U.S. Department  
of Transportation  
**Federal Highway  
Administration**

In Reply Refer To: HSSD/B-168

Thank you for your letter of September 6, 2007, requesting the Federal Highway Administration's (FHWA) acceptance of a Massachusetts Highway Department (MHD) modification to the Minnesota Type Three Combination Bridge Rail. You requested that we find this barrier acceptable for use on the National Highway System (NHS) under the provisions of the National Cooperative Highway Research Program (NCHRP) Report 350 "Recommended Procedures for the Safety Performance Evaluation of Highway Features." Crashworthiness of the Test Level 3 (TL-3) barrier, intended for use on the Annisquam River Bridge, was evaluated using finite element modeling.

## ANNISQUAM RIVER BRIDGE

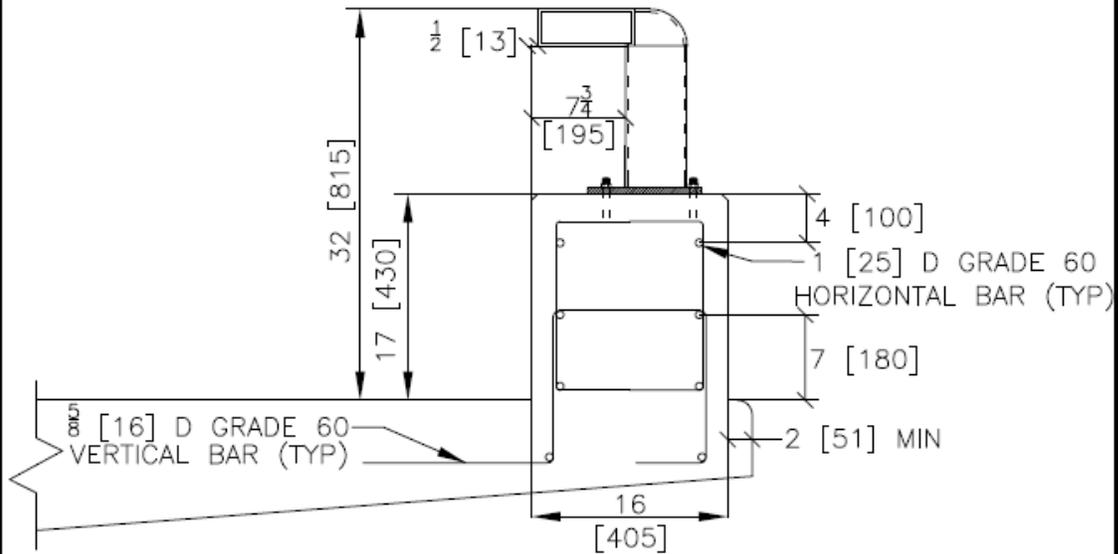
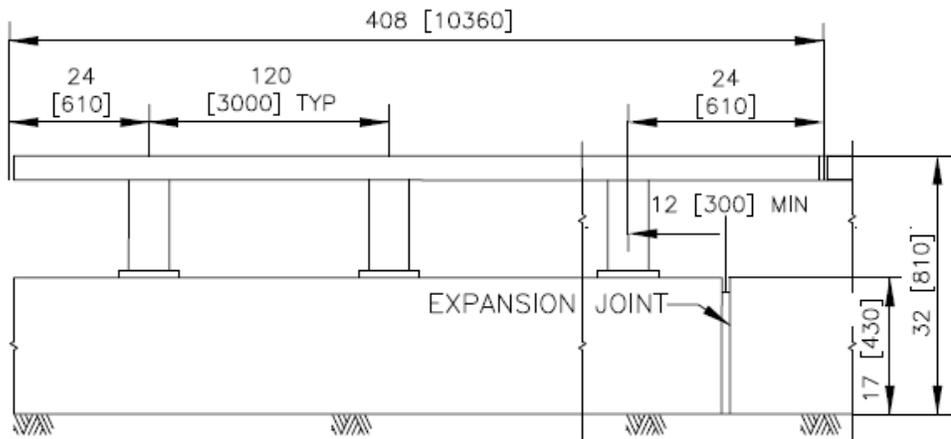
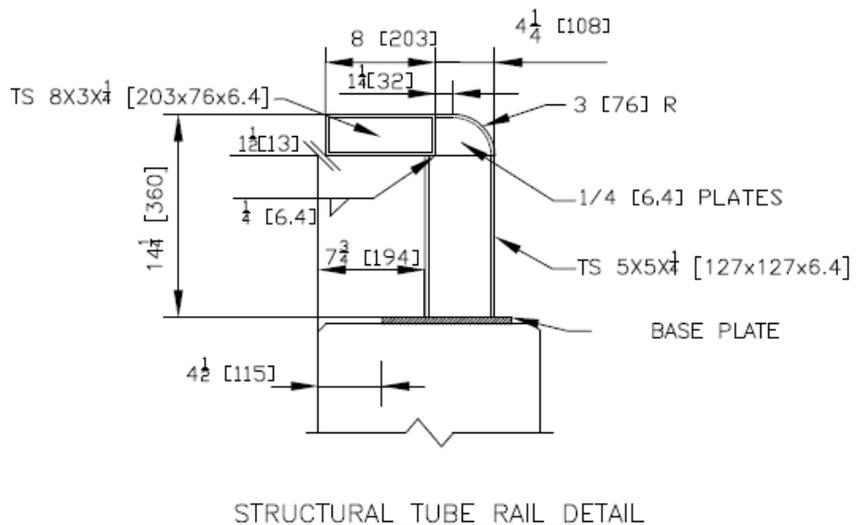
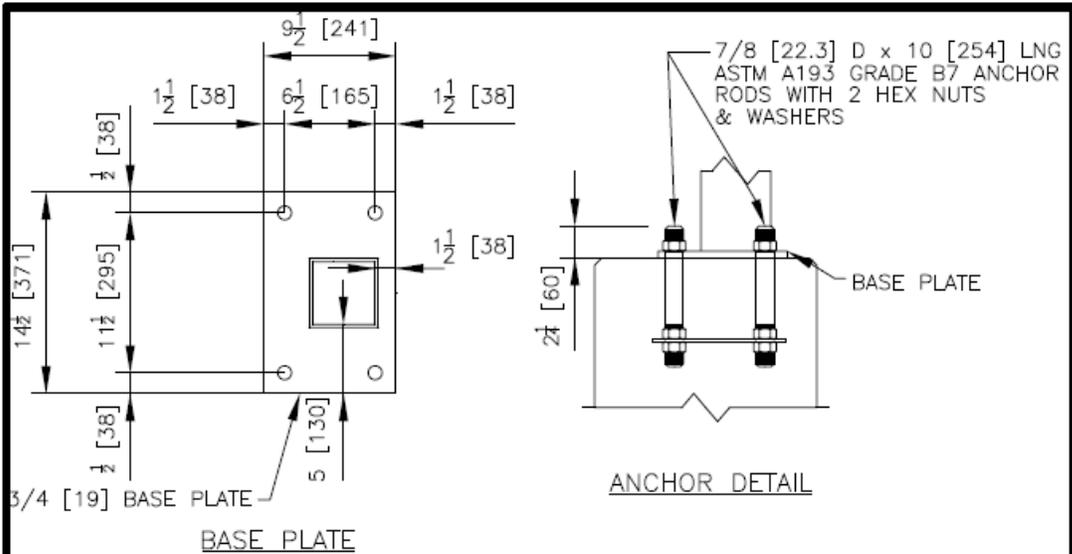
The 35-inch tall Minnesota railing was tested to NCHRP Report 350 TL-4 and accepted by the FHWA in our memorandum "Crash Testing of Bridge Railings" dated May 30, 1997. The 32-inch tall Annisquam/MHD version (shown in the enclosed drawings) varies from the tested railing in a number of dimensions including overall height, height of concrete parapet, and details of the post and rail. The dimensions and test results of the Minnesota TL-4 rail, and the six different Annisquam Bridge railing proposals that were evaluated with finite element analysis (FEA) for TL-3, are detailed in "Table 17", enclosed for reference.

Current FHWA policy does not allow the substitution of computer modeling for the NCHRP Report 350 crash test evaluation of new devices. However, we have considered the results of FEA when evaluating modified devices that had already been evaluated and accepted using full scale crash testing. Because the requested modifications retain the significant structural details of the Minnesota design, and the requested railing is comparable to other crash tested concrete-parapet-and-steel-rail designs, we concur in your assessment.

The bridge rail system described above and detailed in the enclosed drawings is acceptable for use on the NHS under the NCHRP Report 350 Test Level 3 conditions tested, when proposed by a highway agency.
